**LEGAL ADVERTISEMENT
HISTORIC PRESERVATION BOARD
CITY OF PORTLAND**

Project Architect: Jesse Thompson and Richard Lo
Kaplan Thompson Architects

Representatives of 33 Montreal LLC are returning for a second workshop on a proposal for a new 14-unit residential structure at the northeast corner of Montreal and Willis streets on Munjoy Hill. Architects Jesse Thompson and Richard Lo have made a number of design revisions in response to comments and concerns heard at the Board's August 15th workshop and are seeking feedback as to whether the changes successfully address stated concerns.

A design review for the revised proposal for new construction of a multi-family dwelling at 37 Montreal Street was performed by Caitlin Cameron, Urban Designer and Deb Andrews, Historic Preservation Program Manager. The project was reviewed against the *R-6 Small Infill Development Design Principles & Standards* (Appendix 7 of the Design Manual) for Alternative Design Review.

ENTRANCE DETAIL
STUDIES

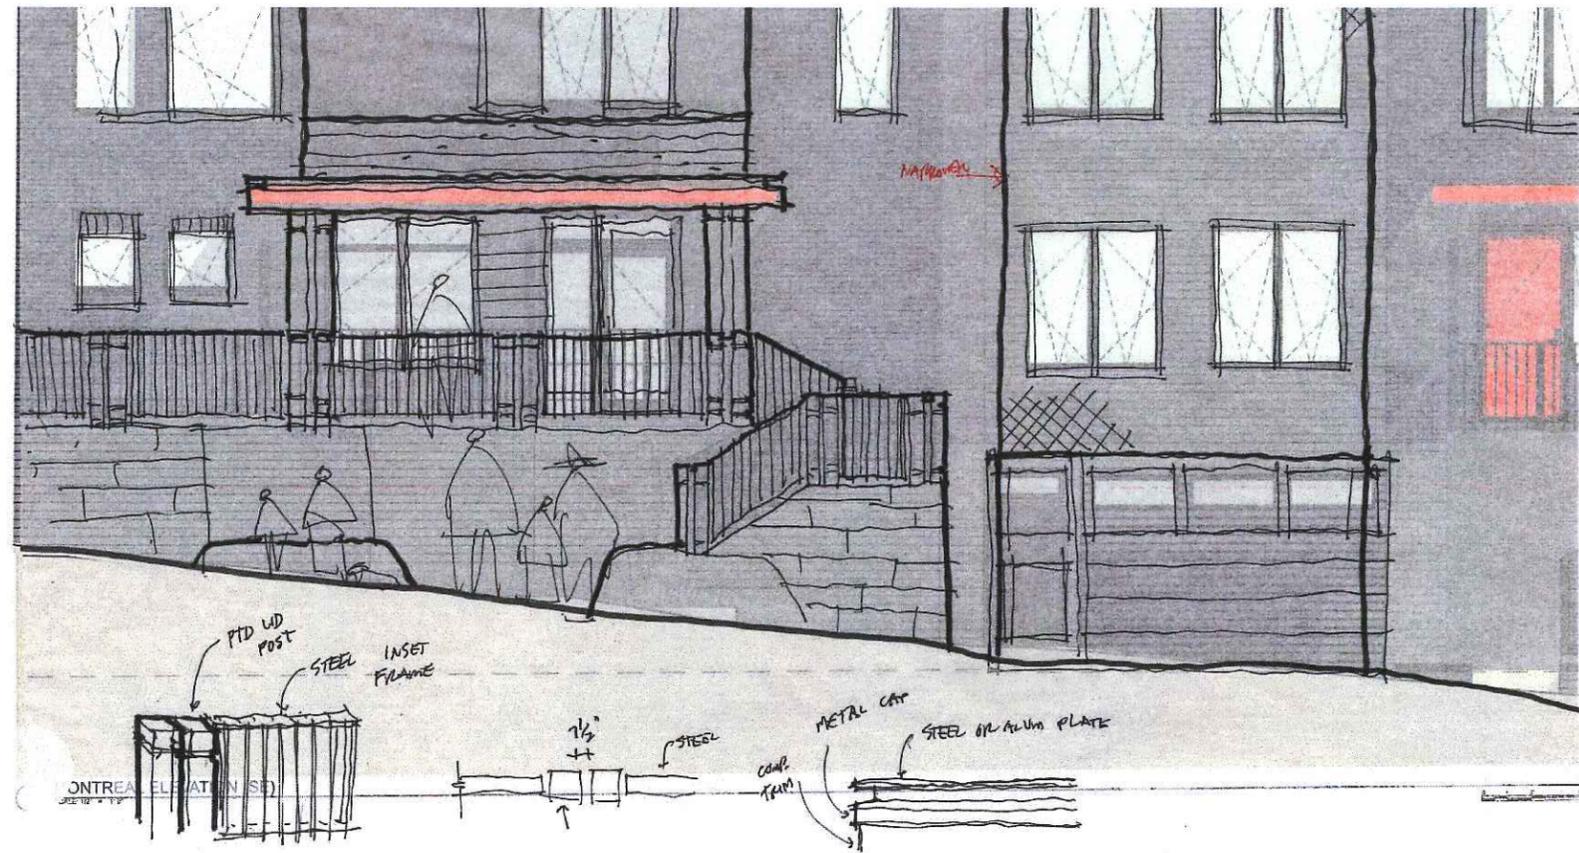
- *C-1 Entrances:* The entries are all street-facing and emphasized with a recess and canopy. **Consider adjusting the design/detail of the multi-family entrance to be more similar to context single and two-family entrances.** The stoops on Willis Street now include details like railings.
- *C-2 Visual Privacy:* Visual privacy is adequately addressed; ground floor windows are higher than 48” above adjoining sidewalk grade.

- *F-4 Delineation between Floors:* The floors are delineated by fenestration patterns, balconies, material changes.
- *F-5 Porches, etc.:* **The front entrance for the multi-family building does not feel resolved – the character does not contribute to the residential character of the neighborhood and is not necessarily incorporated into the overall design. Staff question whether this element could be used to better address the concern about the building/street interface and the approachable, residential character of the larger scale, multi-family building. The design incorporates balconies on top floor by**

10. We have also pulled the central apartment entrance forward and closer to the. The area created by this move has become a terrace on the second floor of the building. This change brings greater visual attention to the intimate entrance area, and makes the scale more residential and less institutional.

11. We have also changed the central “front porch” concept to bring the supporting columns out closer to the street, thickened the roof edge and added decorative trim details, and added intricate human-scaled construction details to the front entrance area.

12. We have modified the hand and guard rail system to be a series of vertical posts with inset metal panels with vertical guards. This should create a more residential feel by removing a continuous top rail across this area.

1 MONTREAL ST ELEVATION STUDY 1

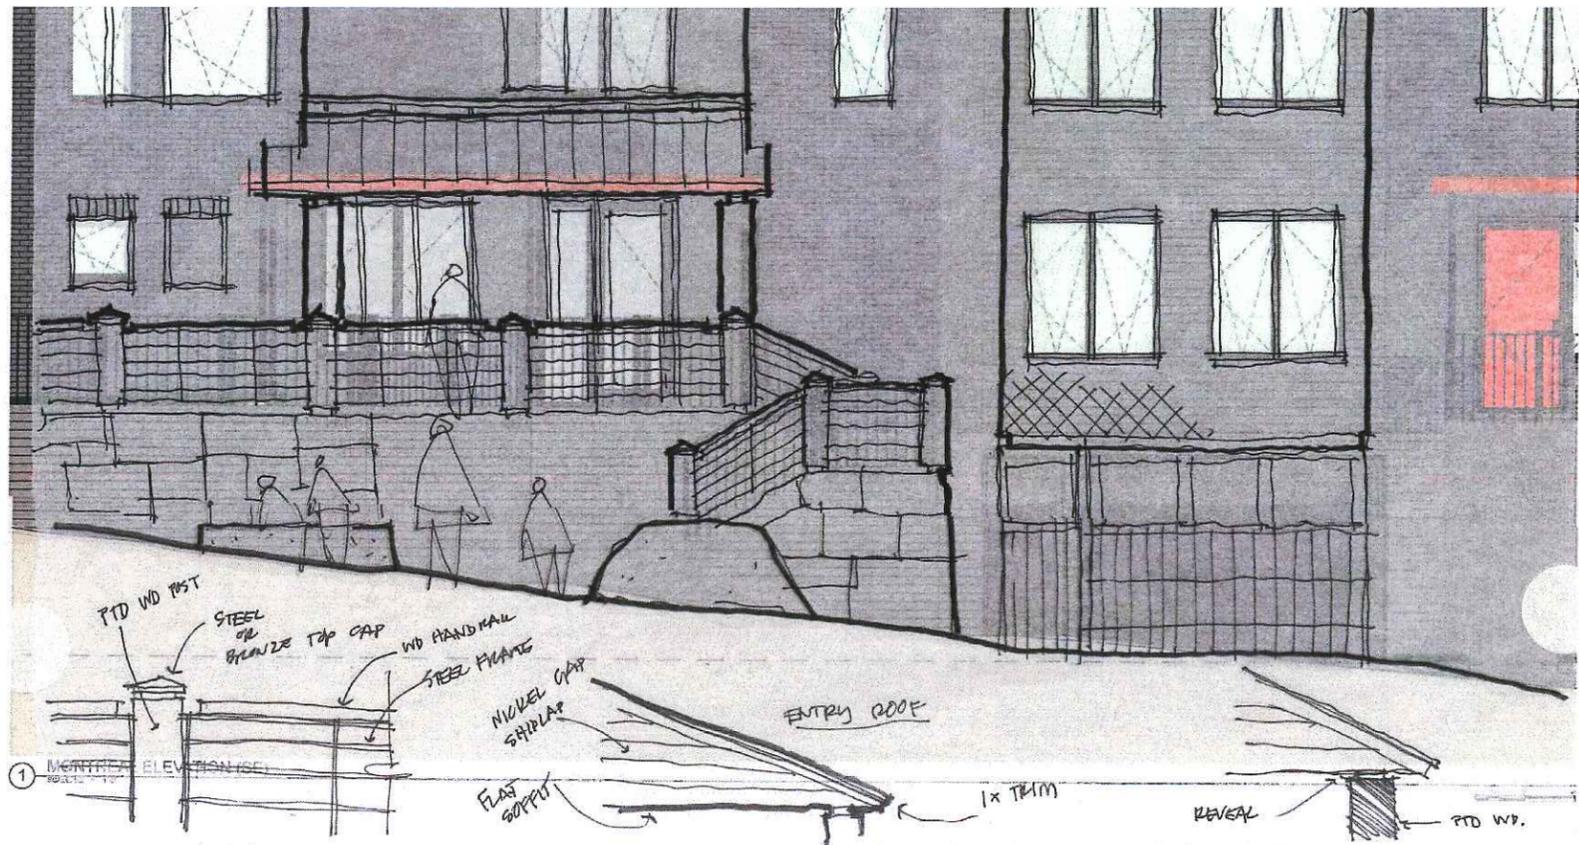
Principle D Proportion and Scale – The building proportions are harmonious in relationship to the overall design and the individual elements are human scaled. **Staff question the scale of the bay windows on Willis Street which are proportionate to the overall scale of the building but large compared with the scale of these elements found nearby. The bays on Montreal Street were reduced and help convey a “side façade” for the townhouses, and bring emphasis to the third story line on the multi-family part of the building.**

- *D-1 Windows:* The majority of windows are rectangular and vertically proportioned; **the applicant revised the window proportions to be more similar with the context.**
- *D-2 Fenestration:* The 12% fenestration requirement is met on street-facing facades.
- *D-3 Porches:* **The design was revised to not include balconies on street-facing facades. The main entrance on Montreal Street could be considered a porch – in which case, the 20% standard is not met. The other dimensional requirements are met in this case. The fourth floor includes roof deck space – the dimensions meet the standard.**

6. The center of the building has been modified to enhance the sense of a “break” between the two living spaces of the building. This center section material has been changed to a flat Shiplap siding material to further accentuate this separation and decrease the visual awareness of the center from the street. These changes are meant to give the perception of breaking the building mass into two separate buildings. We are still evaluating final facade materials and these material selections are subject to change, so we look to the Board’s experience in evaluation of these materials.

7. We have lowered the bay height along Montreal St above the car parking entrance to reduce the overall building scale from the pedestrian way.
8. We have removed the expressed corner windows in the center of the building near the apartment entrance and added a small bay on the upper half of Montreal St.

CONTEXT VIEW FROM
DOWNHILL

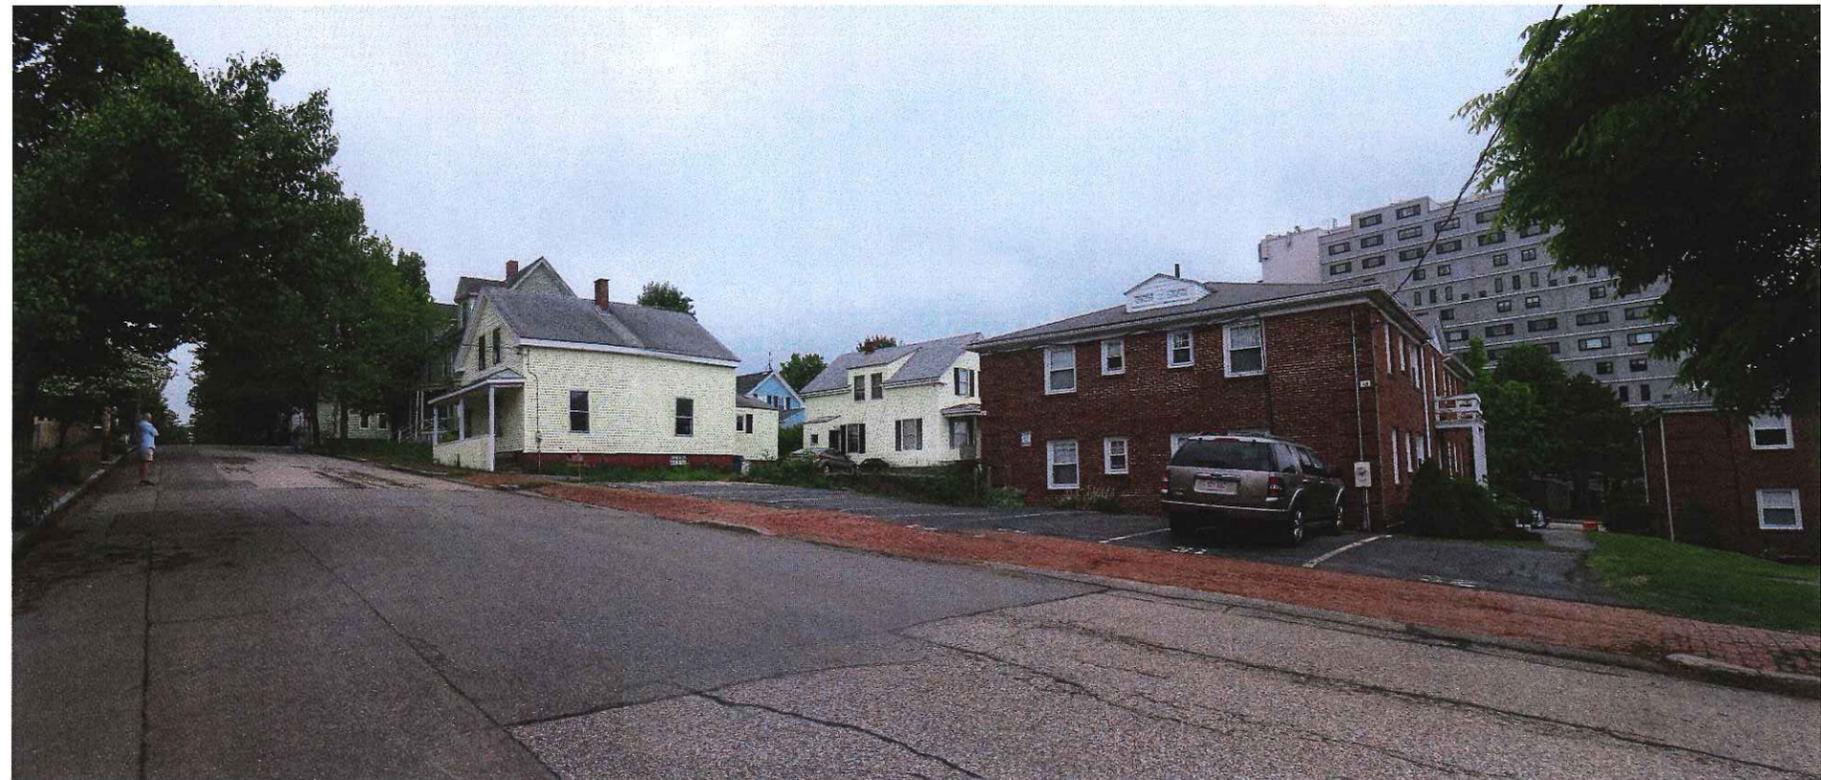
6. Exterior should include shakes and clapboards to reflect neighborhood style.
7. Plans should clearly show view from Walnut St and roof appliances.
8. Butterfly roof is not compatible with neighborhood.
